January 23, 2017

Re: Comments on Revised Application for Marine Mammal Incidental Take Regulations for Geophysical Surveys in the Gulf of Mexico

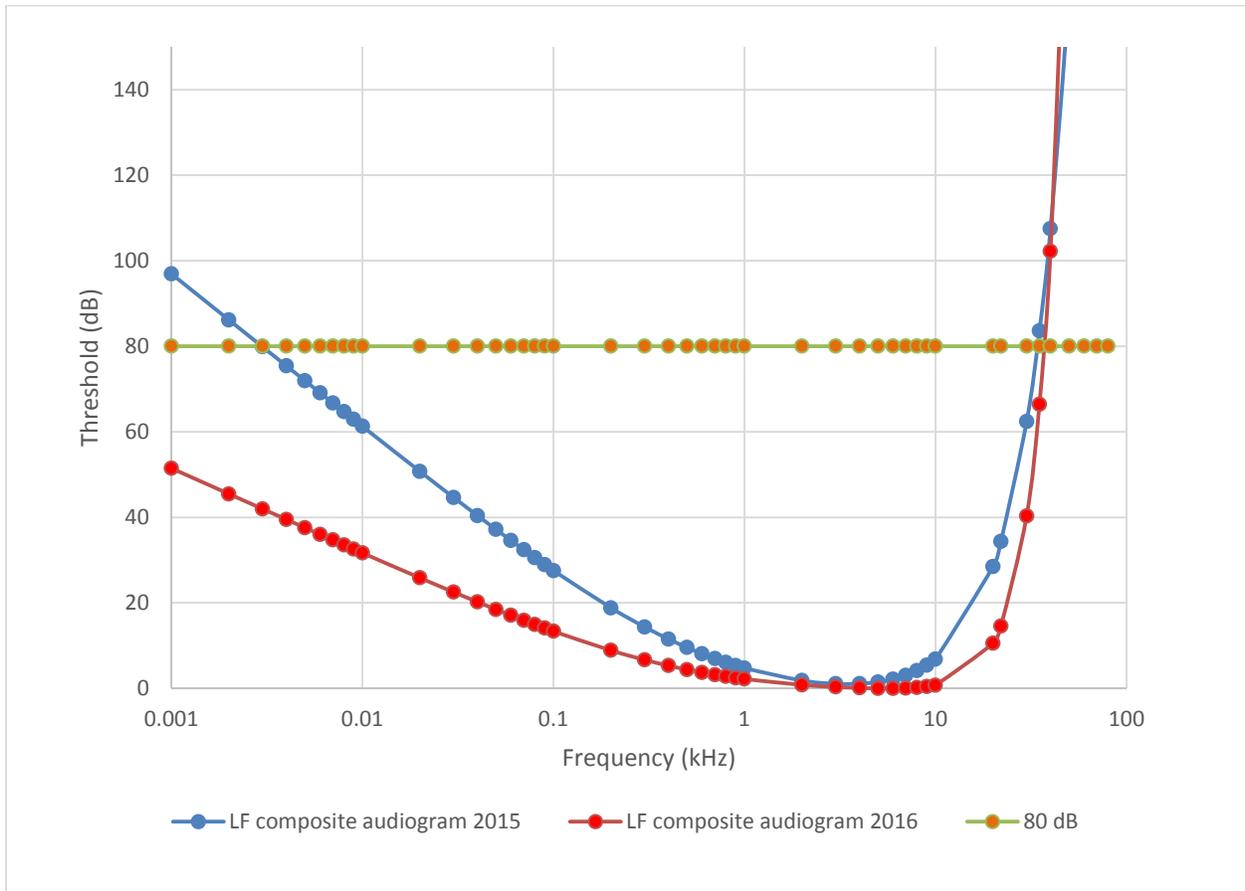
In addition, on page 7 of the 2016 proposed changes, NOAA reviews four models for frequencies of best hearing and states that these models predict “thresholds within ~40 dB of best sensitivity as low as ~30 Hz and up to 25 kHz.” However, rather than use the predictions of these models, NOAA proposes a curve that predicts LF cetaceans can hear 30 Hz at 10 dB above best hearing, not 40 dB. Under NOAA’s model, whales could even hear sound at 10 Hz with only a 25 dB decrement from best hearing—which the best available science for baleen whale hearing modeling (*e.g.*, Houser et al. 2001; Cranford and Krysl 2015) and general mammalian hearing data strongly suggests is impossible. *See infra* footnote 8.

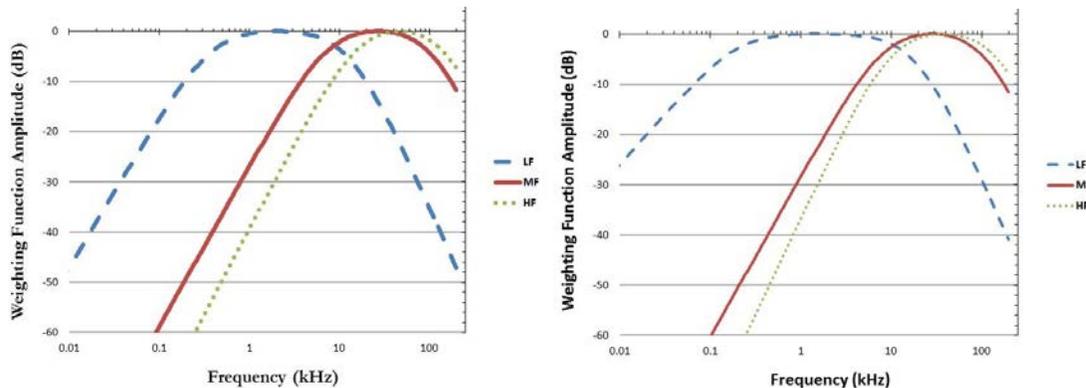
The impact of the new LF cetacean parameters is immediately obvious in our Figure 2 below, which compares Figure PC3⁷ of the new 2016 criteria (*see right plot below*) with the curve depicted in NOAA 2015 Draft Guidance (page 12) (*see left plot below*). In contrast to the similar shapes of all the 2015 weighting functions, the new LF cetacean curve produces a biologically unrealistic, extended, and flattened curve.

NOAA’s proposed LF cetacean model also sharply deviates from data pertinent to other LF specialist mammals. For example, humans are LF hearing specialists that have a best hearing range of approximately 400 Hz to 16 kHz.⁸ But, unlike the LF cetacean model proposed by NOAA, human hearing ability is 25 dB below best hearing at 200 Hz—not the 10 Hz value generated by NOAA’s proposed hearing curve. As another example, the kangaroo rat (another LF hearing specialist) has best hearing that starts to diminish at approximately 500 Hz. By 100 Hz, the kangaroo rat’s hearing threshold is at least 10 dB above best hearing, and at 20-30 Hz is
